Warranty Bulletin

95-41

Date: **December 1995**
 Section: **03**
 Subject: **POLYETHYLENE FUEL TANK MOUNTING**
 Application:

FIGURE 1: NUTS FOR FUEL TANK RETAINING STRAP

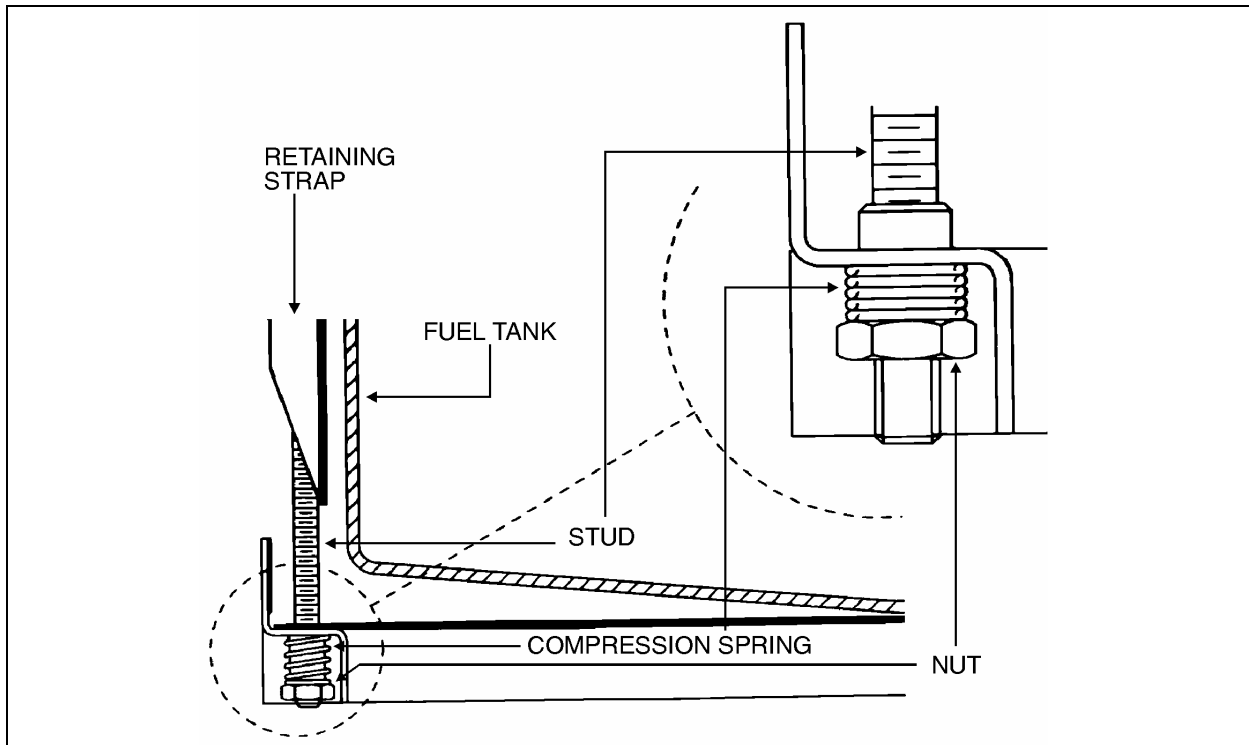
The Prévost Car engineering department has measured, on vehicles equipped with a polyethylene fuel tank, an expansion of the tank after used for a month or more. To avoid tank to be too tight, we ask you to loosen retaining strap nuts as described in the following procedure.

1. Under vehicle, locate fuel tank and the four nuts retaining the two fuel tank retaining straps. (Fig. 1).

2. For each of the 4 nuts:
 - A. Completely unscrew nut.
 - B. Clean nut and stud threads.
 - C. Apply a *Loctite 242™* type removable threadlocker on stud threads.
 - D. Screw nut back again up to coils begin to touch themselves.
